Access Compliance Report

Public Rights-of-Way

Intersection ID: 14235	Main Street: CAMDEN_RD	Cross Street: E_TREMONT_AV	Location: S
ADA ID: D50EAA1F31CF	Ramp Type: Perp	Initial Pass/Fail: Fail	Overall Compliance: No
		Severity Score: 12.5

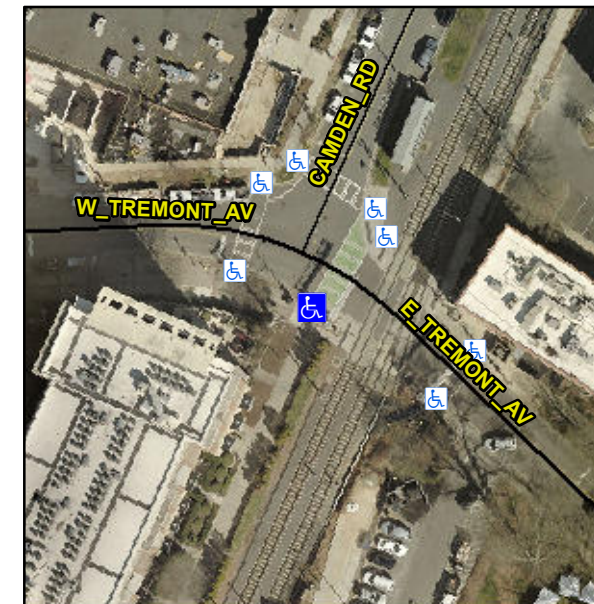
Not Found, R304.2.2

Compliance	Description	Data	Compliance	Description	Data
N/A	Ramp Length (in)	102.0	No	Ramp Slope (%)	8.7
Yes	Ramp Width (in)	114.0	Yes	Ramp XSlope (%)	0.6
N/A	Flare Type LT	N/A	N/A	Flare Type RT	N/A
N/A	Flare Slope LT (%)	N/A	N/A	Flare Slope RT (%)	N/A
N/A	Flare Traversable LT?	N/A	N/A	Flare Traversable RT?	N/A
N/A	Landing Length (in)	N/A	N/A	DWS Provided?	N/A
N/A	Landing Width (in)	N/A	N/A	DWS Contrast?	N/A
N/A	Landing Slope (%)	N/A	N/A	DWS Length (in)	N/A
N/A	Landing X Slope (%)	N/A	N/A	DWS Full Width?	N/A
N/A	Landing Curb? (Y/N)	N/A	N/A	DWS Offset (in)	N/A
N/A	Shared Landing?	N/A			
N/A	Gutter Ponding?	N/A	N/A	Gutter Slope (%)	N/A
N/A	Gutter Lip Ht (in)	N/A	N/A	Gutter X Slope (%)	N/A
N/A	Painted X Walk1?	Yes	N/A	Painted X Walk2?	N/A
	X Walk 1 Direction	To NE		X Walk 2 Direction	N/A
N/A	X Walk 1 Width (in)	145.0	N/A	X Walk 2 Width (in)	N/A
	X Walk 1 Slope (%)	4.1		X Walk 2 Slope (%)	N/A
	X Walk 1 X Slope (%)	2.1		X Walk 2 X Slope (%)	N/A

Remove & Replace Entire Ramp.
